Access Compliance Report

Public Rights-of-Way

Intersection ID: 44052	Main Street: KETTLEWELL_LN	Cross Street: LONGSTONE_LN	Location:	N
ADA ID: 876139A0D24F	Ramp Type: PerpDiag	Initial Pass/Fail: Fail	Overall Compliance: No	Severity Score: 8.75
Codes/Mitigation Info/Possible Solution		Field Measurements/Component Compliance

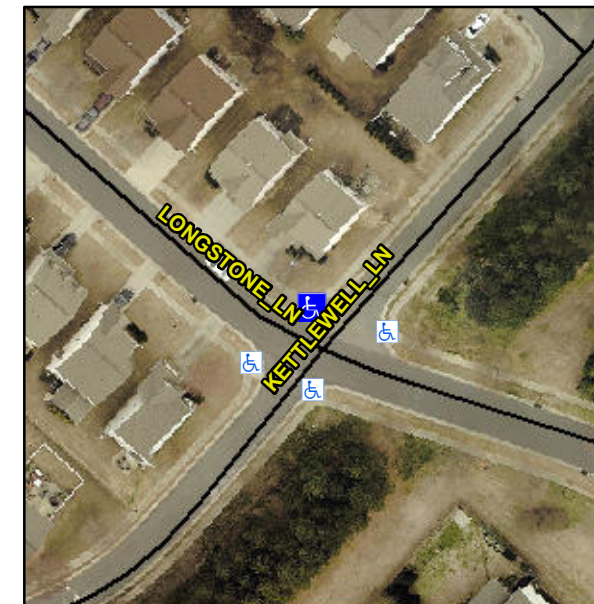
Compliance	Description	Data	Compliance	Description	Data
N/A	Ramp Length (in)	104.5	Yes	Ramp Slope (%)	7.1
No	Ramp Width (in)	40.5	Yes	Ramp XSlope (%)	0.3
N/A	Flare Type LT	N/A	N/A	Flare Type RT	N/A
N/A	Flare Slope LT (%)	N/A	N/A	Flare Slope RT (%)	N/A
N/A	Flare Traversable LT?	N/A	N/A	Flare Traversable RT?	N/A
N/A	Landing Length (in)	N/A	N/A	DWS Provided?	N/A
N/A	Landing Width (in)	N/A	N/A	DWS Contrast?	N/A
N/A	Landing Slope (%)	N/A	N/A	DWS Length (in)	N/A
N/A	Landing X Slope (%)	N/A	N/A	DWS Full Width?	N/A
N/A	Landing Curb? (Y/N)	N/A	N/A	DWS Offset (in)	N/A
N/A	Shared Landing?	N/A			
N/A	Gutter Ponding?	N/A	N/A	Gutter Slope (%)	N/A
N/A	Gutter Lip Ht (in)	N/A	N/A	Gutter X Slope (%)	N/A
N/A	Painted X Walk1?	No	N/A	Painted X Walk2?	No
	X Walk 1 Direction	To SW		X Walk 2 Direction	To SE
N/A	X Walk 1 Width (in)	N/A	N/A	X Walk 2 Width (in)	N/A
	X Walk 1 Slope (%)	1.6		X Walk 2 Slope (%)	1.8
	X Walk 1 X Slope (%)	2.2		X Walk 2 X Slope (%)	0.7

Remove & Replace Curb Ramp With Two New Directional Ramps or Equivalent.
